RUHE SUBDIVISION
MAJOR SUBDIVISION #2013-201
ATTACHMENTS

TO: PLANNING COMMISSION
FROM: GREGG ADAMS, PLANNER
SUBJECT: RUHE SUBDIVISION
MINOR PLAN 2013-201
REQUEST FOR MAJOR PLAN REVIEW

SUBJECT: South Whitehall Township
Ruhe Major Subdivision #2013-201
Preliminary/Final Plan Review

EXISTING FEATURES (EXPANDED VIEW, 60 SCALE)
RUHE MINOR SUBDIVISION PRELIMINARY/FINAL PLAN
 2442 HUCKLEBERRY ROAD
 SOUTH WHITEHALL TOWNSHIP
 LEHIGH COUNTY, PENNSYLVANIA

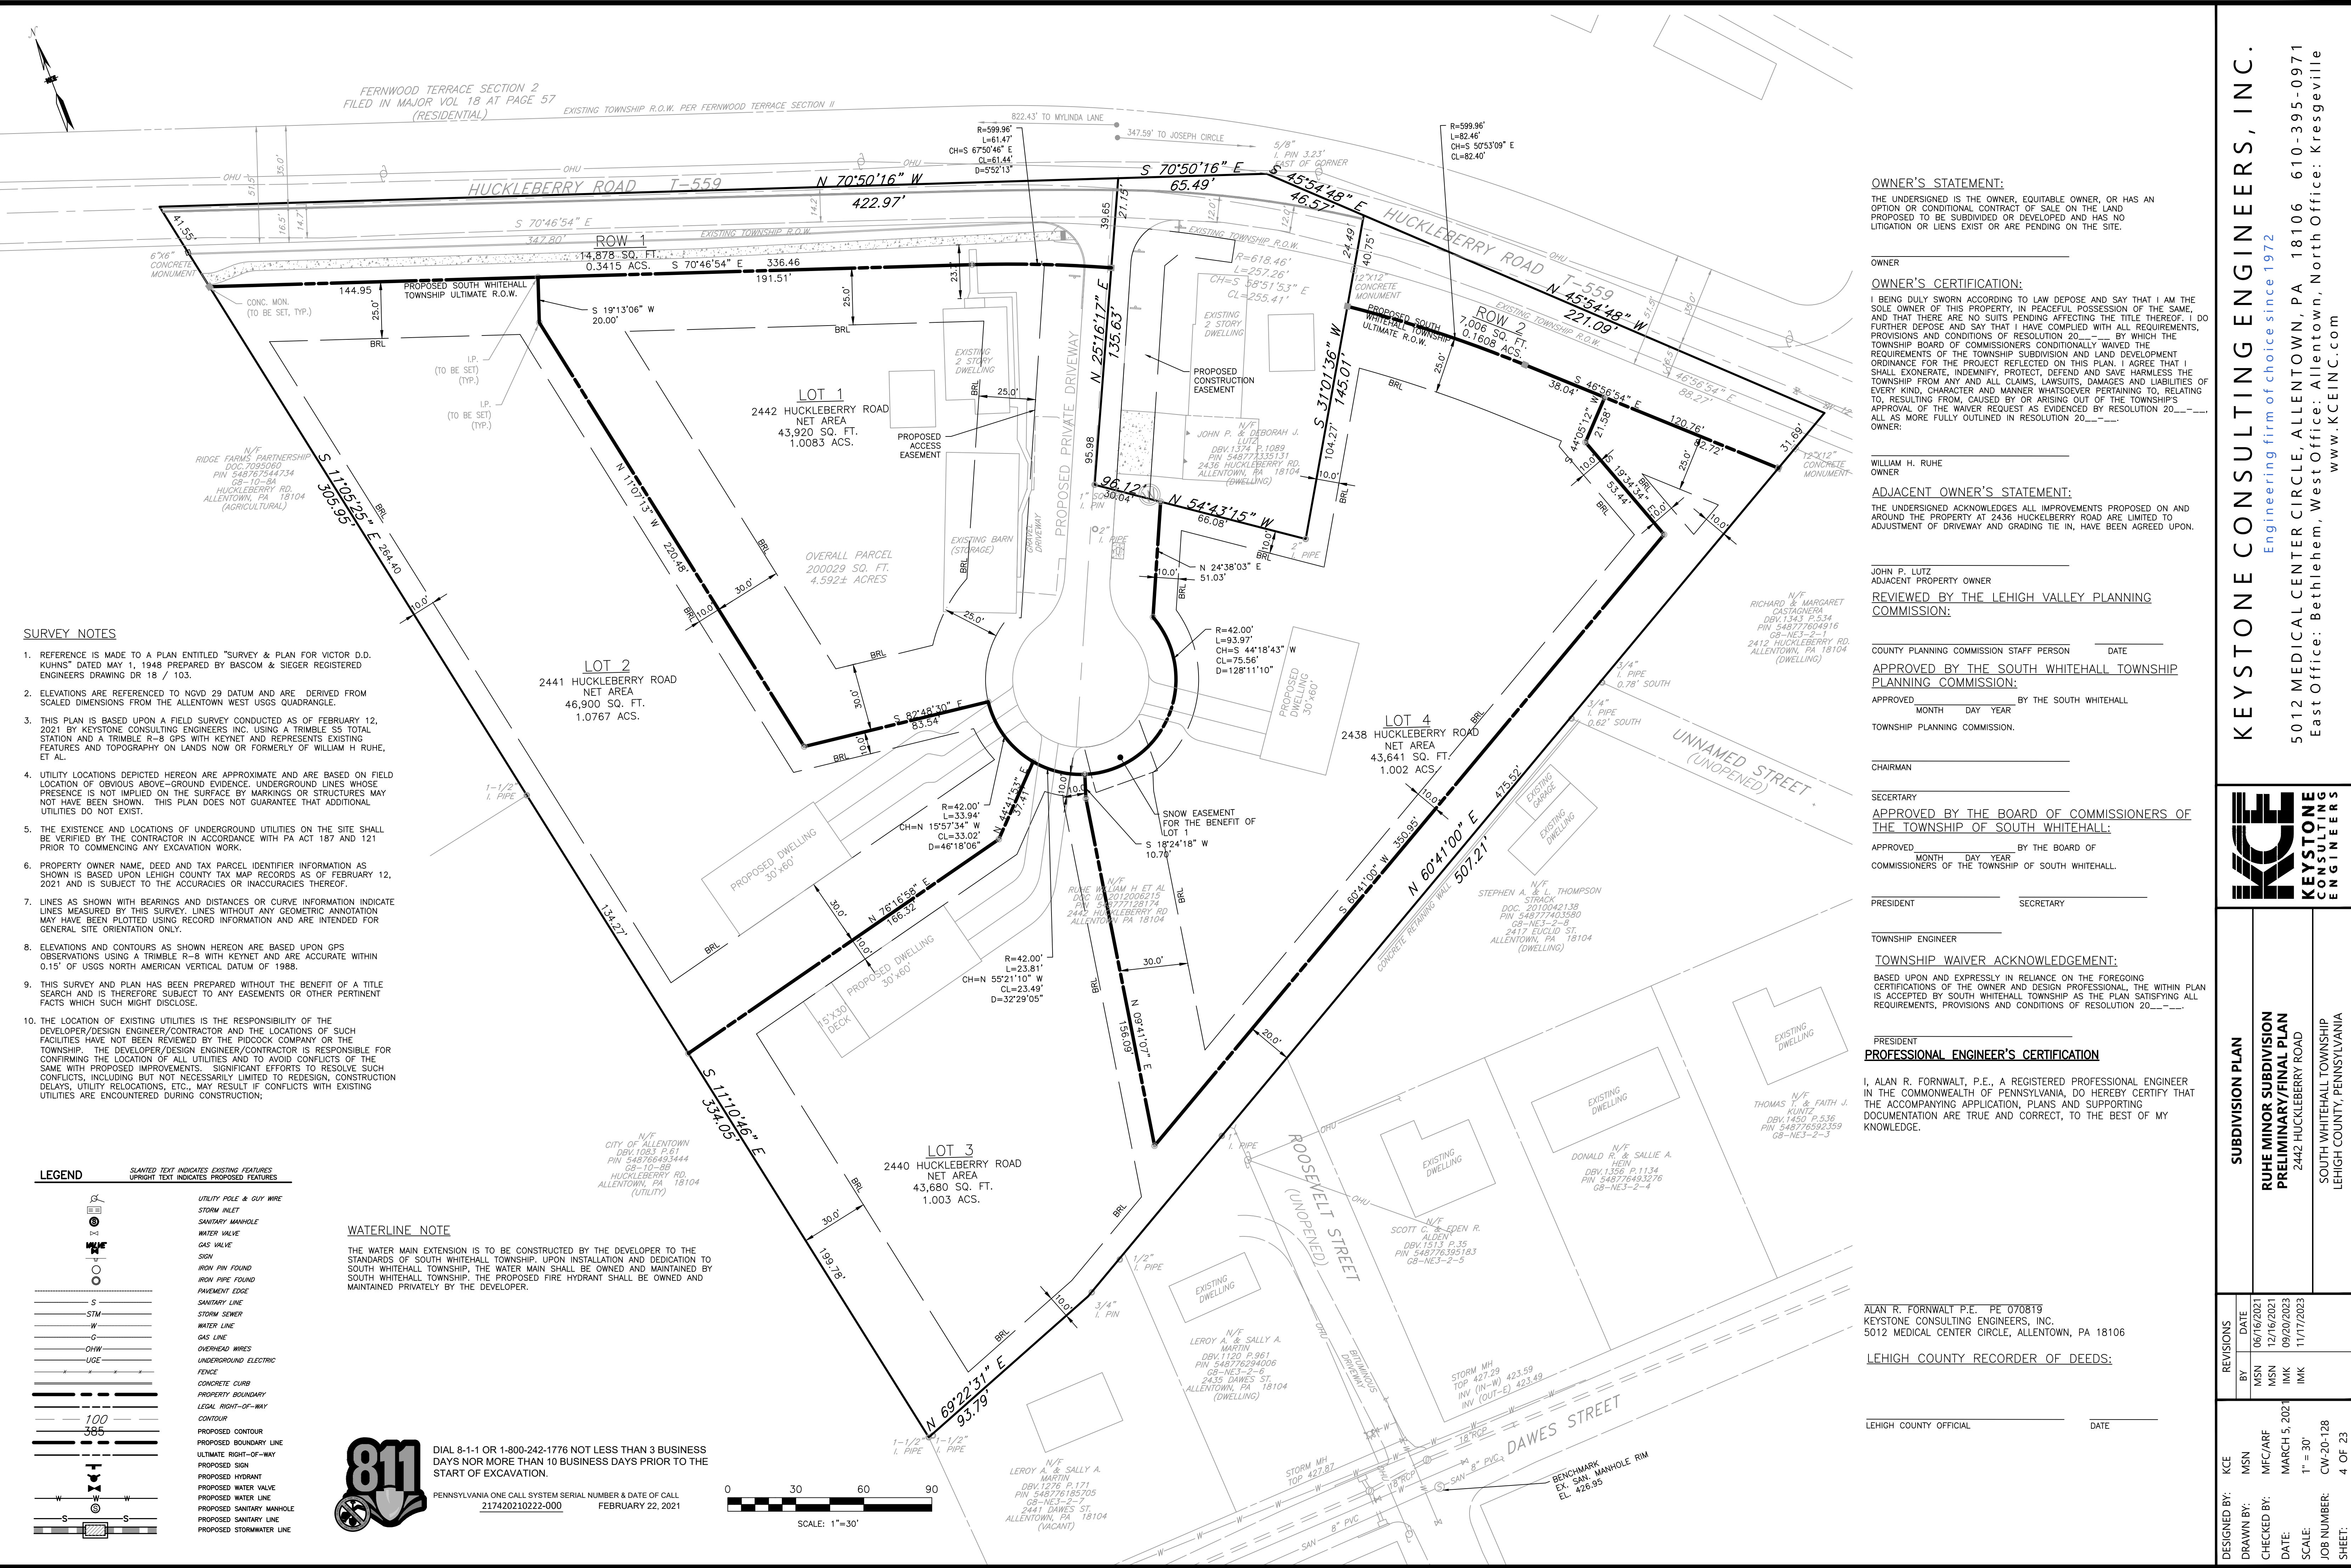
6. We note the following survey related comments:
 - a. Check the scale of the Existing Features (Expanded View, 60 Scale) Plan (Sheet 3). The plan does not appear to be drawn to scale;

GRADING & DRAINAGE PLAN
RUHE MINOR SUBDIVISION
PRELIMINARY/FINAL PLAN
2442 HUCKLEBERRY ROAD
SOUTH WHITEHALL TOWNSHIP
LEHIGH COUNTY, PENNSYLVANIA

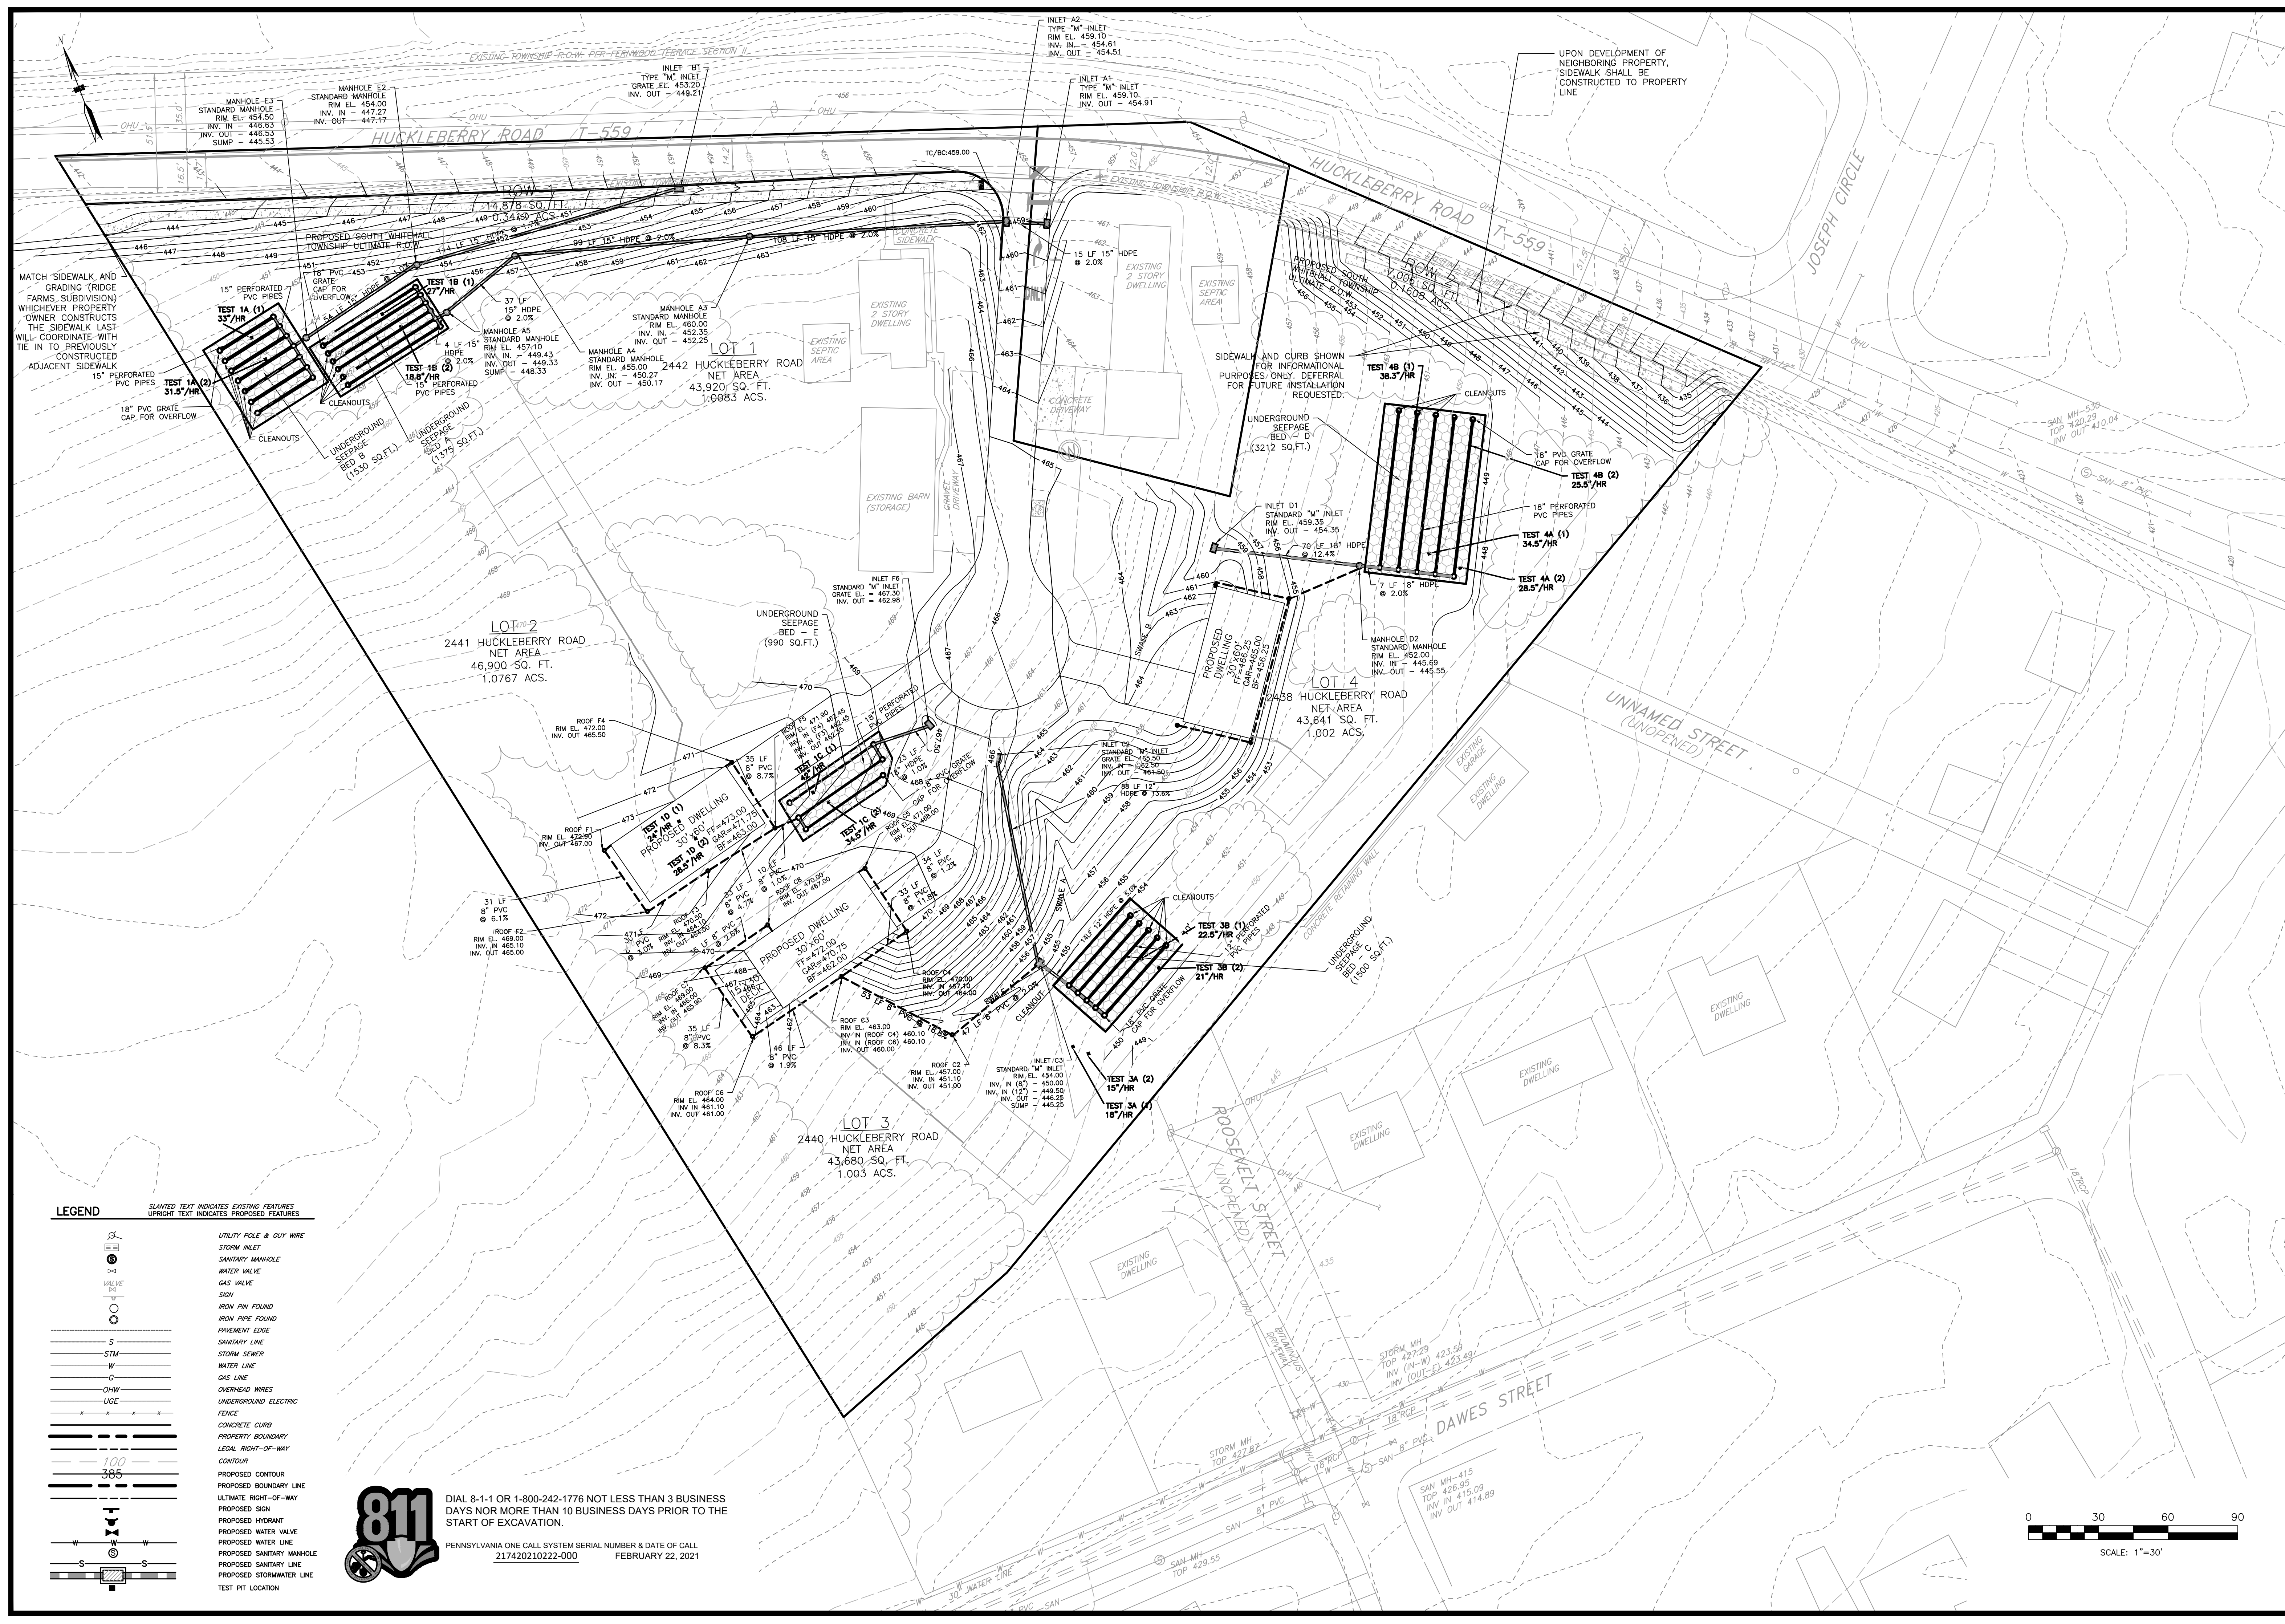
4. Grading is shown on the adjacent property to the west. In addition to the “Match Sidewalk and Grading” Note (Sheet 9) obtain and show necessary construction easements. We note that the design will lower the edge of the road approximately 2.5 feet and should be designed in a manner that will not rely on construction of the adjoining development;

UTILITY PLAN	
RUHE MINOR SUBDIVISION	
PRELIMINARY/FINAL PLAN	
2442 HUCKLEBERRY ROAD	
SOUTH WHITEHALL TOWNSHIP	
LEHIGH COUNTY, PENNSYLVANIA	
DESIGNED BY:	KCE
DRAWN BY:	MSN
CHECKED BY:	MFC/ARF
DATE:	March 05, 2021
SCALE:	1" = 30'
JOB NUMBER:	CW-20-128
SHEET:	10 OF 23

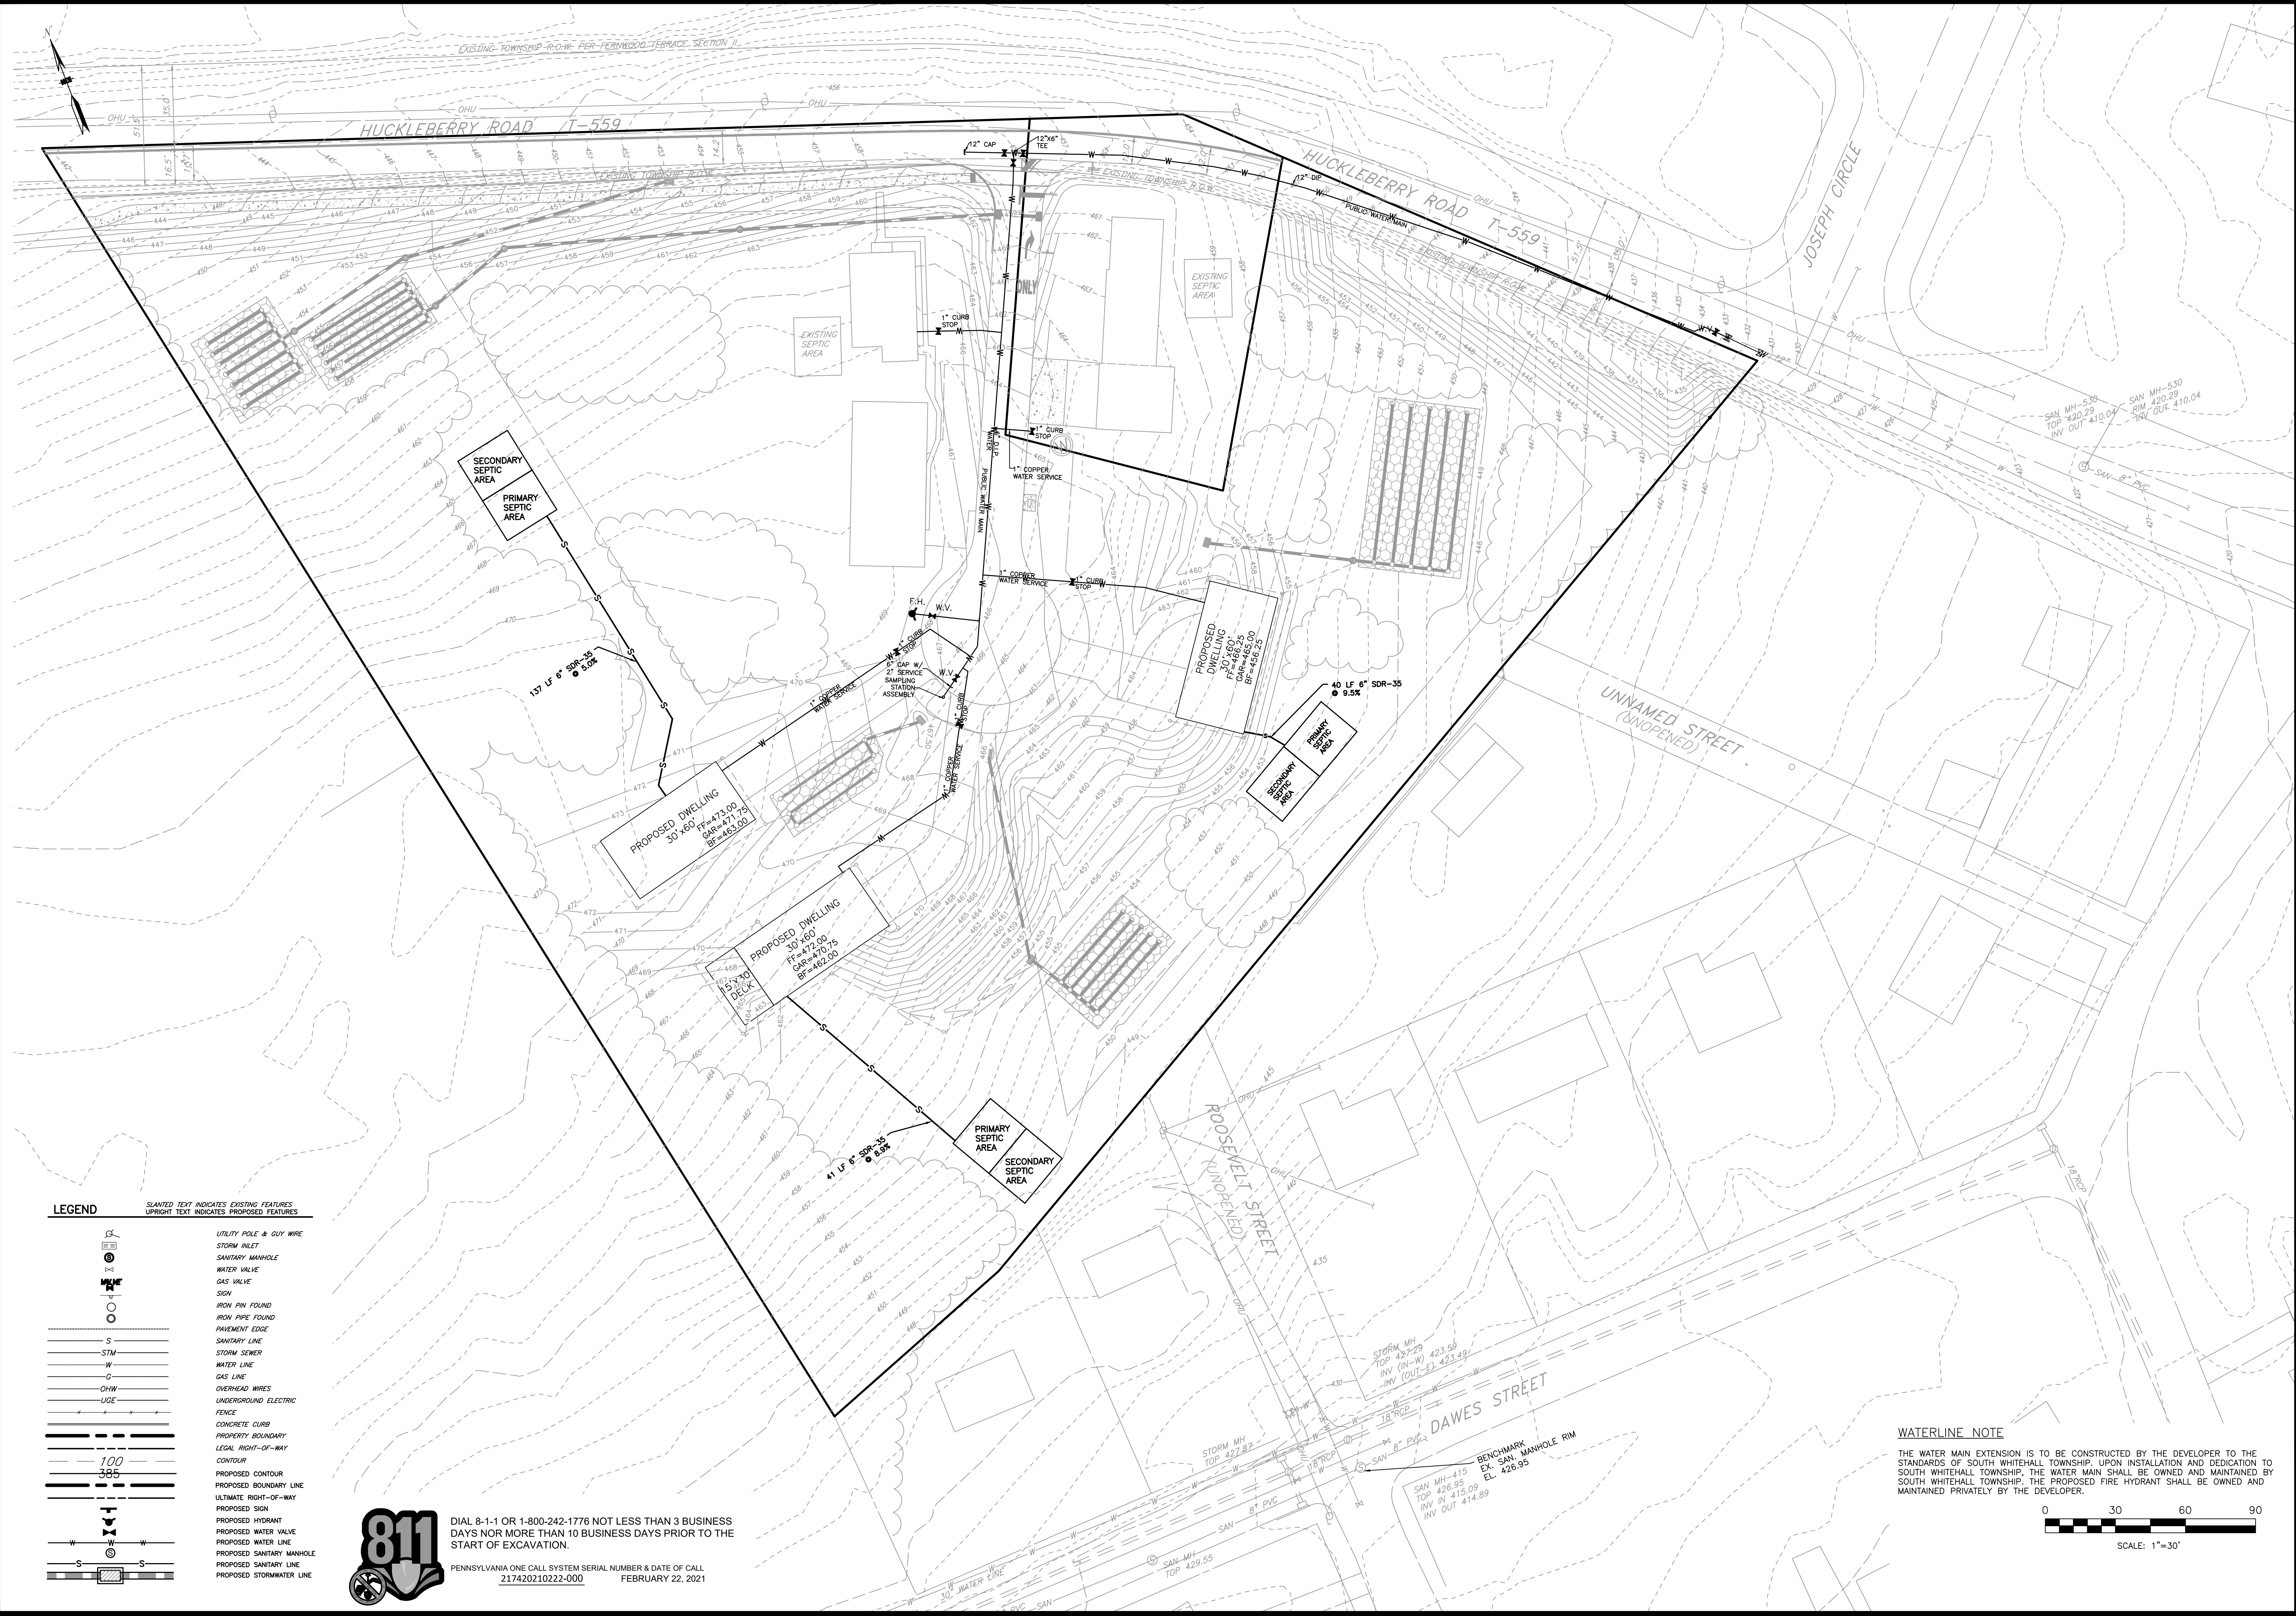
1. **Utility Plan: Sheet 10 of 23:**

- A. Install 2" waterline blow-off at Station 0+10 [SWT Standard SWT-W-4]
 - B. Relocate private fire hydrant valve to street public water main area. [Must use a 6" hydrant tee and valve]
 - C. Curb Valves should be located 2'6" off of Cartway.
- Water Line Easement Legal Description and Exhibit: Revised 11-08-2023**
- D. Exhibit page 2: Sample Station Assembly is shown in wrong locate. [Show in correct location in waterline easement area.]
